Changes in the Revision

Responses to the Reviewer's Comments

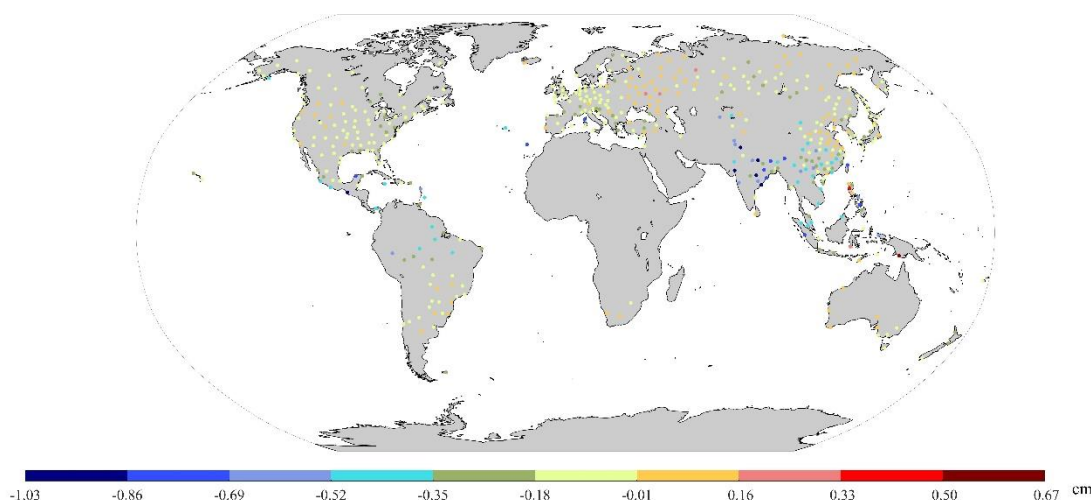
(2) Color bars of figures: Figures 1–8 use a discrete color bar which contains quite similar colors at the lower and higher end (light pink, orange) which can be misleading. Furthermore, the steps between colors are in most cases not equidistant, which makes a visual interpretation difficult, especially for the map plots. I suggest to use for all figures a color bar and colors e.g. similar to the ones in Fig. 9, or maybe even a conceptually uniform color map.

Response: Good suggestion. The color bar is changed in all figures. We have tried to plot all figures with equidistant steps; however, the presentation is unclearly because there is a lot of sites with the same color as shown in the below figure.

Besides, there is the color even unused in the presentation of this figure. Therefore, the steps between colors are not equidistant and we emphasize this in the revision (lines 318-320).
